Amendments to the Drawings

Remarks

This is responsive to the Office Action of December 30, 2005. These amendments and remarks are proper, do not introduce new matter, are not narrowing in view of a rejection over a cited reference, are clarifying in nature and serve to substantiate why the application is in proper condition for reconsideration and allowance.

FIG. 8

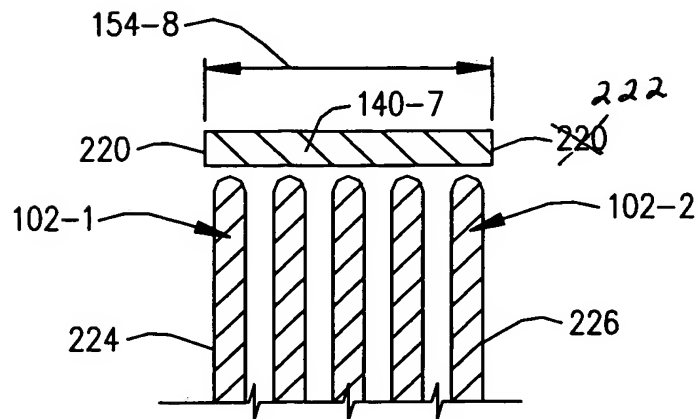
The attached sheets of drawings include amendments to FIGS. 8, 9 and 13. FIG. 8 has been amended to change one of the items 220 to item 222. FIG. 9 has been amended to change item 107-7 to item 170-7. FIG. 13 has been amended to change “RETRACK” to “RETRACT” in block 258.
